Modifications for the Kenwood TM-732

Picture(s) of Kenwood - TM-732

Photo shows radio after modification.

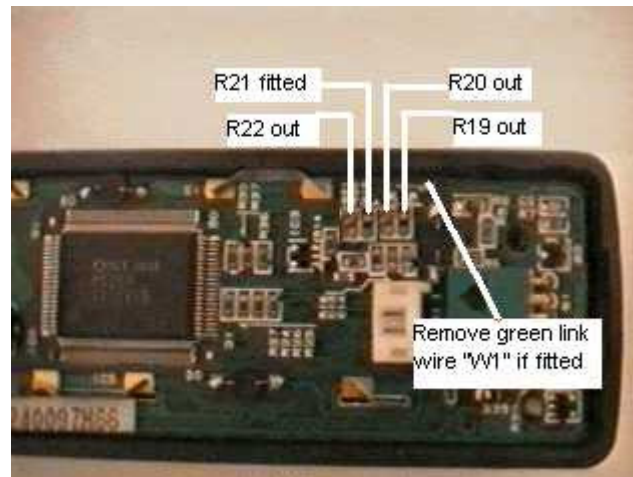
5. On the back of the remote head remove the two screws.
6. Now you should be able to see the PCB of the remote head.
7. If you look above the white connector "CN 1" you will see four "0" Ohm resistor positions, la R19,R20,R21 & R22.
8. You need to configure the resistors as in the photo below.

TX-RX Unit 430 MHz
(X57-4000 B/4)
Foil side.

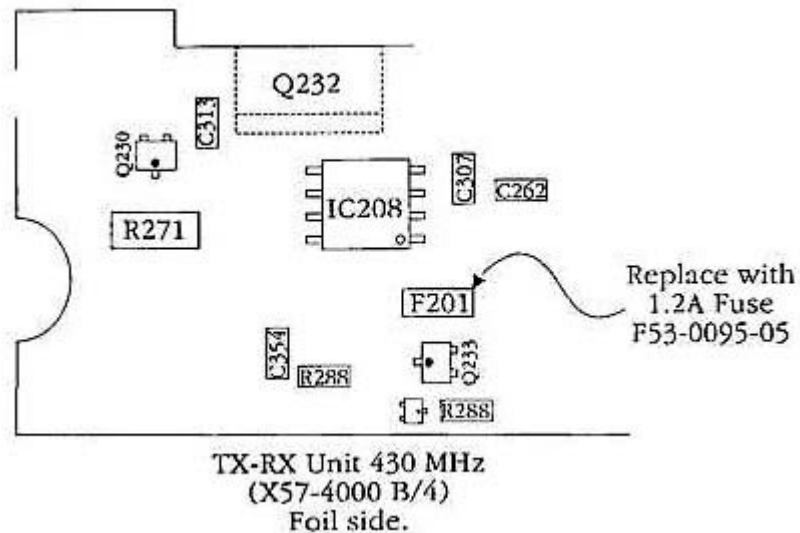
Parts change:
Change the chip fuse from 1 A to 1.2 A in the 430 MHz unit (X57-4000-11 B/4) whenever servicing this board.

Parts required:
F201, chip fuse, 1.2 Amp, (F53-0095-05), QTY. 1

Service Bulletin no. 1011 (3 May 1993)

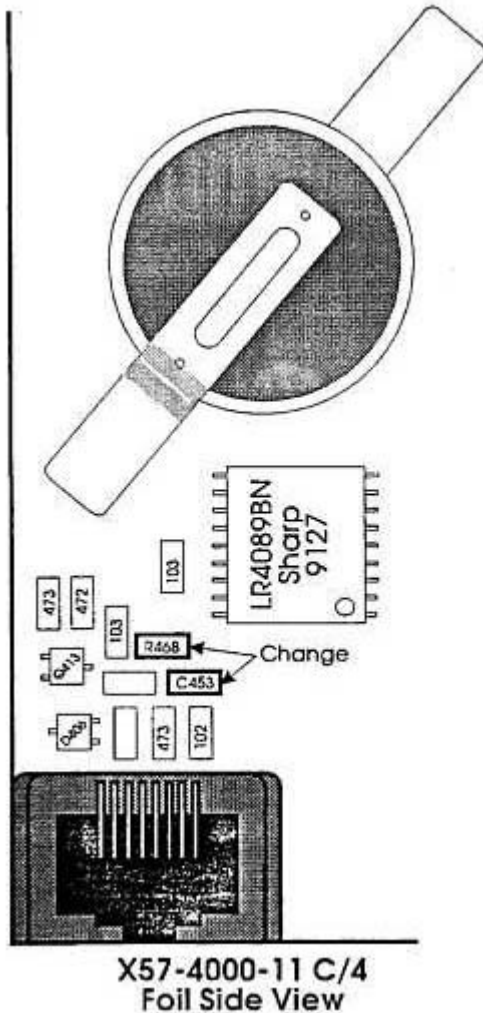
Symptom:
Improper DTMF operation and low microphone audio have been reported by several owners of the TM-732A when the units are operated in the Cross-band repeat mode.

```
Parts required:
R468    39 Kohm chip resistor    RK73FB2A393J    QTY. 1
C453    .01 µF chip capacitor    CK73FB1E103K    QTY. 1
```

5. Replace R468 and C453 shown in the accompanying diagram.

Service Bulletin no. 1014 (10 May 1993)

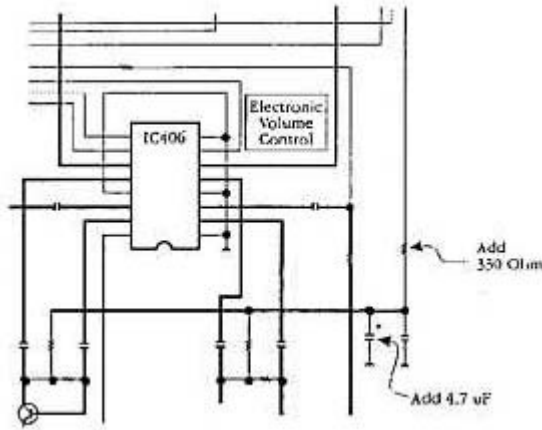
Symptom:
While receiving a signal on one band a noise is heard in the speaker whenever the squelch on the other band opens or closes.

Add a 330 ohm resistor and 4.7 µF capacitor to the 5C line in the control unit (X57-4000-11 C/4).
Cut the 5C line and add the 330 ohm resistor in series.

Parts required:
```
330 ohm resistor      RD14BB2C331J   QTY. 1
4.7 µF capacitor      C92-0507-05    QTY. 1
```

Service Bulletin no. 1023 (26 May 1993)

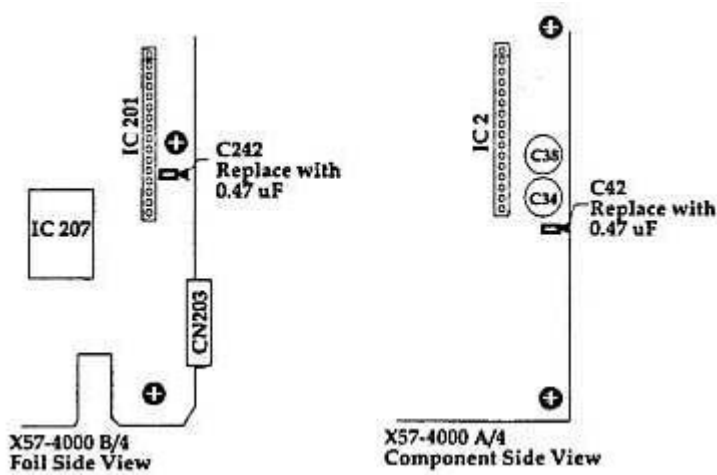
Symptom:
On some early versions of the TM-732 scan will not stop when operating in the S-meter squelch mode, even when the transceiver receives a signal with the same level as specified when initiating the S-meter squelch mode.

Correct action:
Change the value of C42 in the 144 MHz TX/RX unit (X57-4000 A/4) and C242 in the 430 MHz TX/RX unit (X57-4000 B/4) from 1 µF to 0.47 µF.

Qty	Description	Kenwood Part No.	Circuit description
2	0.47 µF capacitor	CK73FF1C474Z	C42, C242

430 MHz TX-RX Unit
X57-4000-11
Foil Side View

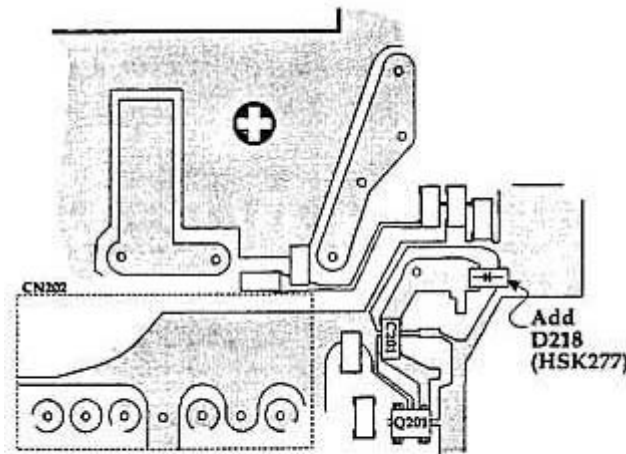
Symptom:
Q201 the first RF amplifier in the 430 MHz unit fails at random.

Corrective action:
Moddition of diode D218 in parallel with diode D214 in the RA line provides increased surge protection for Q201.

Qty	Description	Kenwood Part No.	Circuit description
1	Diode	HSK277	D218
